Pacific Gas & Electric Company
ELC (Corp ID 39)
Status of Advice Letter 6378E
As of December 17, 2021

Subject: CA Flats Solar 130, LLC Electric Wire Crossing PG&E's 500KV Exclusive Electric Easements - Request for Approval Under Public Utilities Code Section 851, pursuant to General Order 173

Advice 6378-E

Site Plan
 Figure 2
 County of Monterey

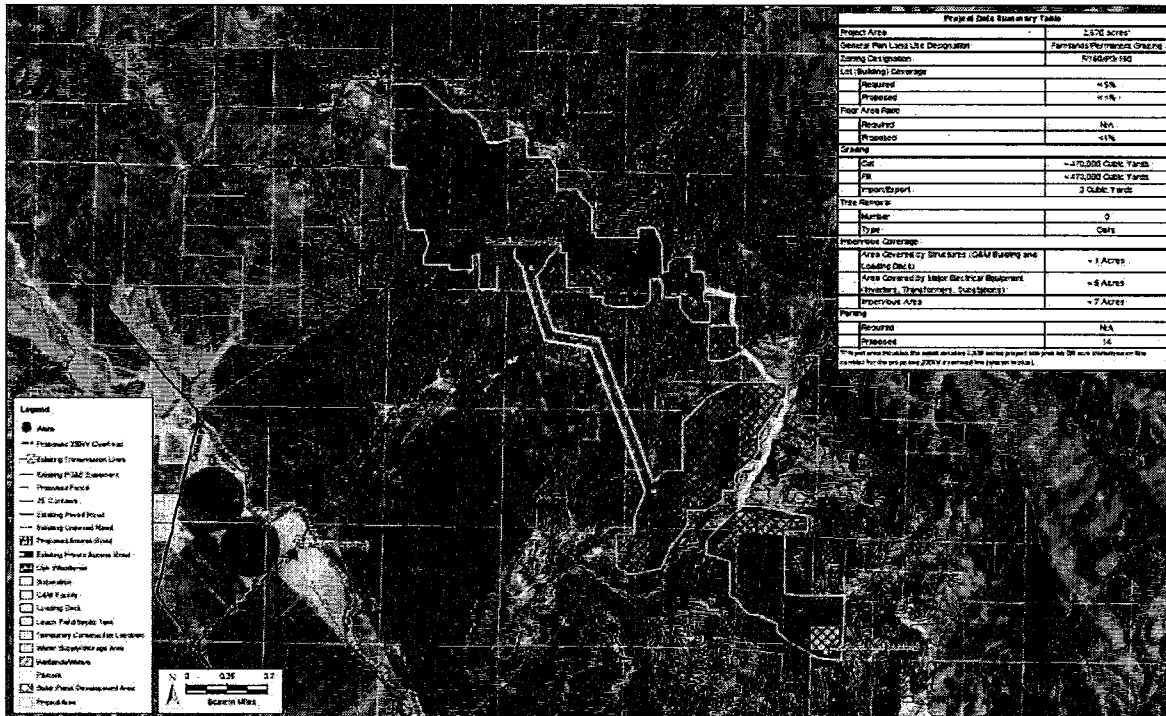
2. Project Setting Section 2.4.1/Prevailing Winds – This section, as well as Figure 2.4a, indicate there are two rural residences located in close proximity to the site (775 feet N to NW of site). The attached wind rose from Parkfield (2008-2010) suggests that prevailing daytime winds during construction work hours are generally from the SE. This would put the residences, as well as the
